TOLEDO - LUCAS COUNTY PLAN COMMISSIONS

REF: SUP24-0007

SUBJECT: Request for a Special Use Permit for Used Auto Sales Lot at 2204 N Reynolds Road

SITE PLAN

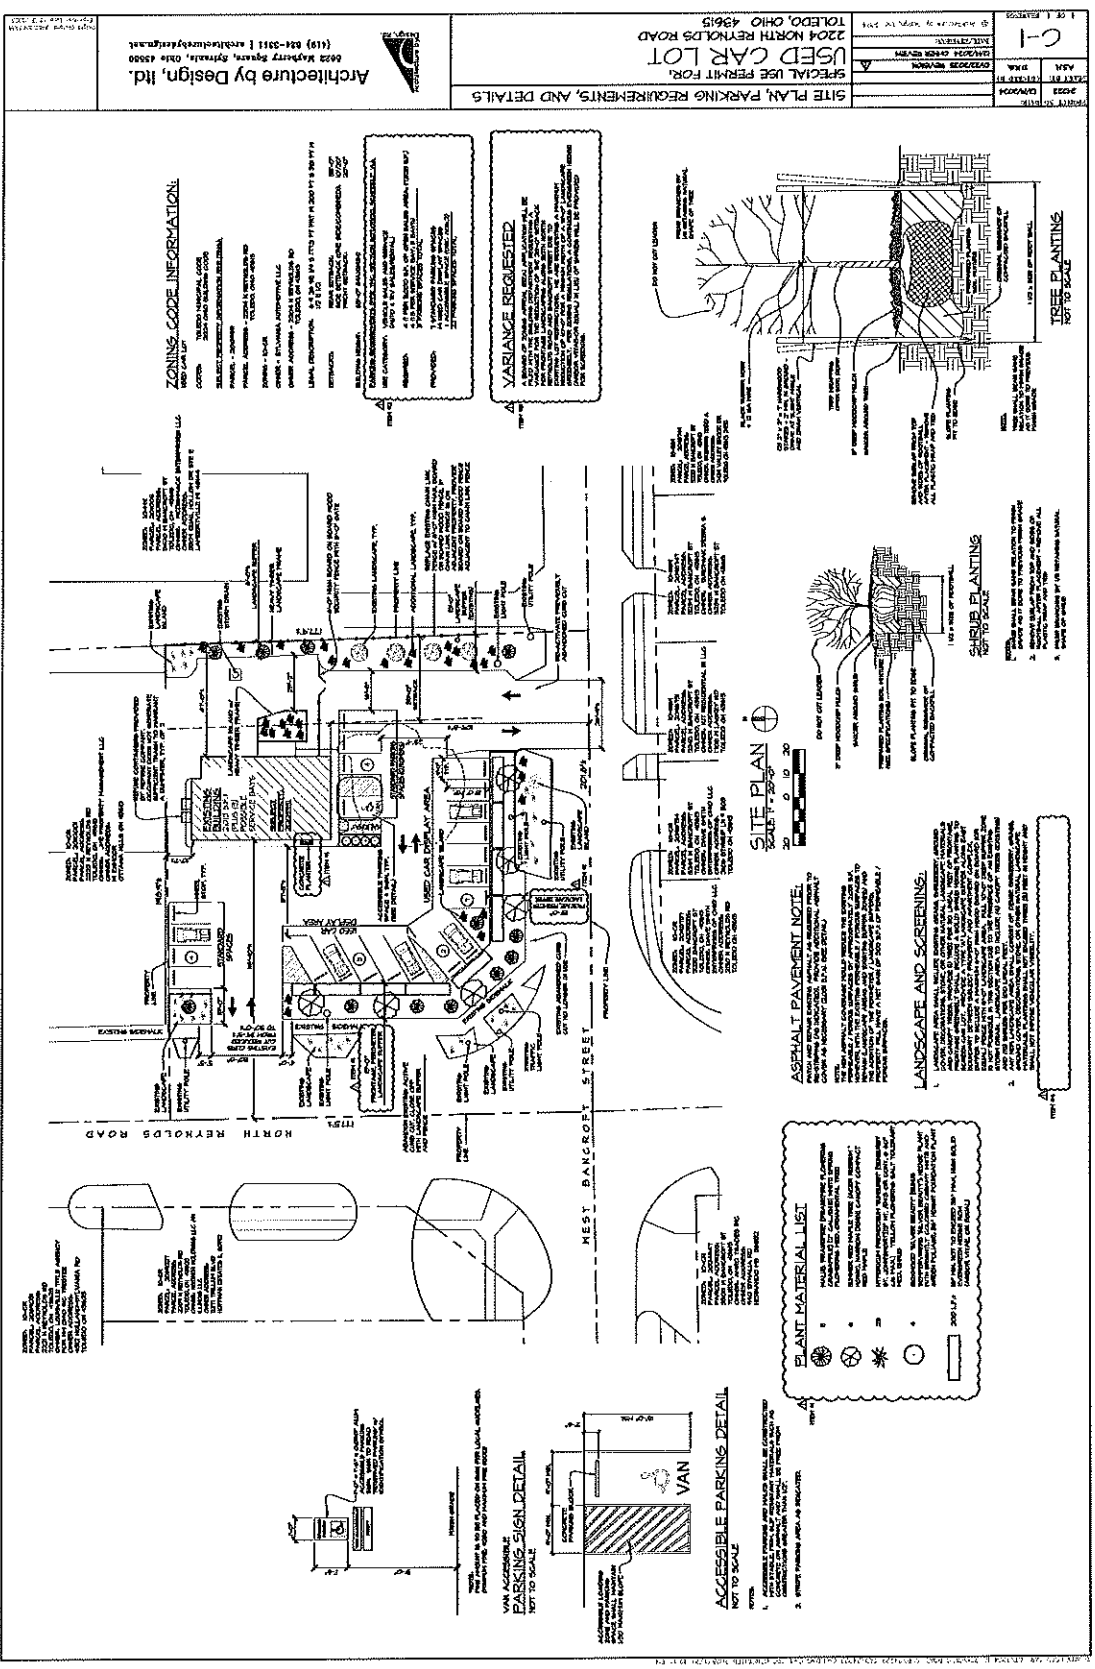
Landscape buffers are required per TMC§1108.0203 – *Buffer and Screening Requirements*. As shown in Table 1108.0203, the northern property line next to CR does not require a buffer. However, the eastern property line requires a Type A buffer to the adjoining RM Multi-Dwelling Residential district. The Type A landscape buffer requires four (4) canopy trees and either fifteen (15) or twenty (20) shrubs for every 100 feet. The site plan shows the chosen buffer following the fifteen shrubs requirement which includes a solid fence or wall as part of the landscaping. The wall is shown in the site plan, but the property buffer width is not shown in the site plan.

Behind the existing building, the landscape buffer recedes to a six (6) feet width to accommodate the existing storm drain. As a condition for approval, the landscape buffer shall be extended to the required ten feet (10') with reasonable accommodations made to account for the storm drain. A revised site plan shall be submitted as part of the conditions of approval.

Parking lot interior and perimeter landscaping is required per TMC§1108.0204 – *Parking Lot Landscaping (Interior and Perimeter)*. The parking lot perimeter landscaping overlaps entirely with the buffer and frontage greenbelt requirements and as such, meet the requirements for this section. The interior landscaping, as shown in the site plan, currently do not meet the standards listed in TMC§1108.0204(B) – *Area and Dimensional Standards*. Of note is the heavy timber framing for the landscape island in the side yard. Per TMC§1108.0204(B)(2), the frame must be made of six inch (6") by eighteen inch (18") concrete curbing. Finally, TMC§1108.0205 – *Interior Site Landscaping* details the requirements for landscaping around the principal building. The site plan is sufficient for the required three (3) two-inch (2") caliper tree for the existing building's footprint. A revised site plan shall be submitted as part of the conditions of approval.

8. Sidewalks are required along West Bancroft through drive apron to property line per **TMC§1107.1303. A revised site plan shall be submitted showing this modification.**

- b. A Type "A" landscape buffer along the south and west property lines. A ten foot (10') wide buffer with six (6) trees and twenty-three (23) shrubs is required along the east property line. **Not acceptable as depicted on landscaping plan submitted. The buffer shall be extended to ten feet (10') wide while making reasonable accommodations for the existing storm drain shall be provided and shown on a revised landscaping plan.**

- e. Interior parking lot landscaping per TMC§1108.0204. Four (4) canopy trees and 12 shrubs are to be provided. One (1) tree and 8 shrubs are depicted on the landscape plan. **Not acceptable as depicted on landscaping plan submitted. Three (3) additional canopy trees and four (4) shrubs shall be provided and shown on a revised landscaping plan.**

- f. Interior parking lot landscaping design standards per TMC 1108.02204(B). Landscaping areas within the parking area must be constructed with 6 inch by 18 inch concrete curbing, cast-in-place, extruded, or by some other process approved by the Planning Director, to minimize damage to plant material. One (1) of the landscaping island uses heavy timber frame. **Not acceptable as depicted on landscaping plan submitted. The landscaping island modification shall be provided and shown on a revised landscaping plan.**
